Access Compliance Report

Public Rights-of-Way

(Curb Ramps)

Intersection ID: 47976	Main Street: AVALY_LN	Cross Street: ARDREY_KELL_RD	Location: NE
ADA ID: 8C968696980C	Ramp Type: PerpDiag	Initial Pass/Fail: Fail	Overall Compliance: No
		Severity Score: 21.25

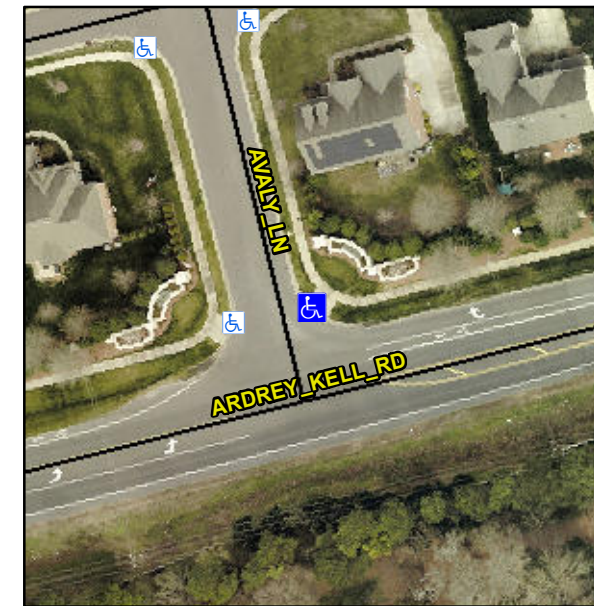
Not Found, R304.5.1, R304.2.2

Compliance	Description	Data	Compliance	Description	Data
N/A	Ramp Length (in)	115.0	No	Ramp Slope (%)	8.8
No	Ramp Width (in)	47.0	Yes	Ramp XSlope (%)	0.3
N/A	Flare Type LT	N/A	N/A	Flare Type RT	N/A
N/A	Flare Slope LT (%)	N/A	N/A	Flare Slope RT (%)	N/A
N/A	Flare Traversable LT?	N/A	N/A	Flare Traversable RT?	N/A
N/A	Landing Length (in)	N/A	N/A	DWS Provided?	N/A
N/A	Landing Width (in)	N/A	N/A	DWS Contrast?	N/A
N/A	Landing Slope (%)	N/A	N/A	DWS Length (in)	N/A
N/A	Landing X Slope (%)	N/A	N/A	DWS Full Width?	N/A
N/A	Landing Curb? (Y/N)	N/A	N/A	DWS Offset (in)	N/A
N/A	Shared Landing?	N/A			
N/A	Gutter Ponding?	N/A	N/A	Gutter Slope (%)	N/A
N/A	Gutter Lip Ht (in)	N/A	N/A	Gutter X Slope (%)	N/A
N/A	Painted X Walk1?	No	N/A	Painted X Walk2?	No
	X Walk 1 Direction	To W		X Walk 2 Direction	To S
N/A	X Walk 1 Width (in)	N/A	N/A	X Walk 2 Width (in)	N/A
	X Walk 1 Slope (%)	2.7		X Walk 2 Slope (%)	1.0
	X Walk 1 X Slope (%)	1.4		X Walk 2 X Slope (%)	0.7

Remove & Replace Curb Ramp With Two New Directional Ramps or Equivalent.
